STAFF REPORT ADDENDUM

APPLICATION SE 2013-DR-001

APPLICANT: TD Bank, National Association

PROPOSAL: To replace existing 1,781 sf service station with a 2,616 sf financial institution with two drive-thru lanes.

SHEET NUMBER:
6
OF 6

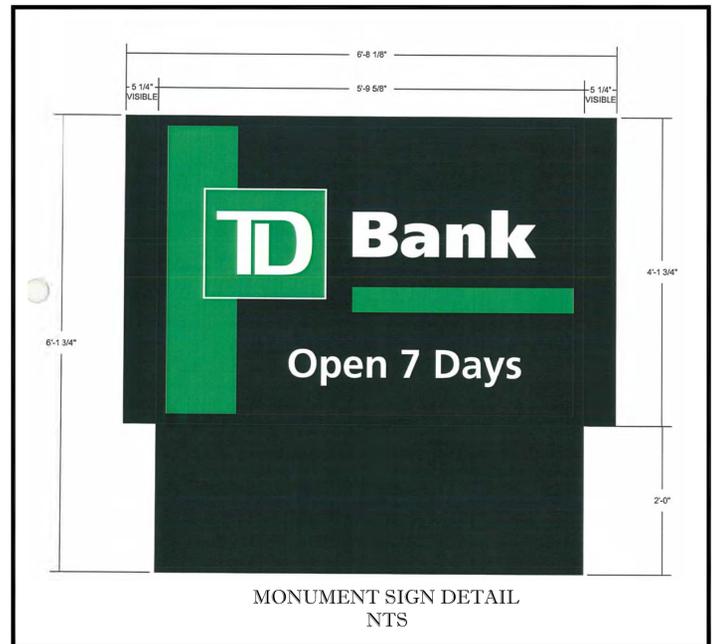
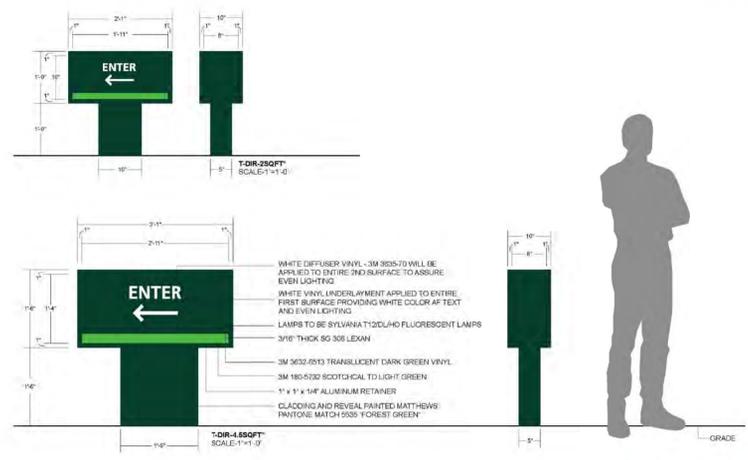
- The SE Plat has been revised (with a date of December 19, 2013), and includes the following changes:
 - The temporary remediation shed is now shown as 8-feet by 45-feet in size.
 - An erroneous ATM detail was deleted from Sheet 6 to correct a previous error.
- Proposed Development Conditions were revised (now dated January 8, 2014), as highlighted on Attachment 2 of this addendum, and include the following major revisions:
 - Development Condition Number 8, regarding the erroneous ATM detail addressed above, is no longer required and was deleted. This deletion resulted in the renumbering of the remaining conditions.
 - Development Condition Number 12 (now Number 11) was revised to state:

~~8. The Remote ATM detail, located in the upper right corner of Sheet 6 of the SE Plat, should be disregarded. The proposed ATM shall be inset into the southeast façade of the bank building, as correctly shown on the South Elevation on Sheet 6.~~
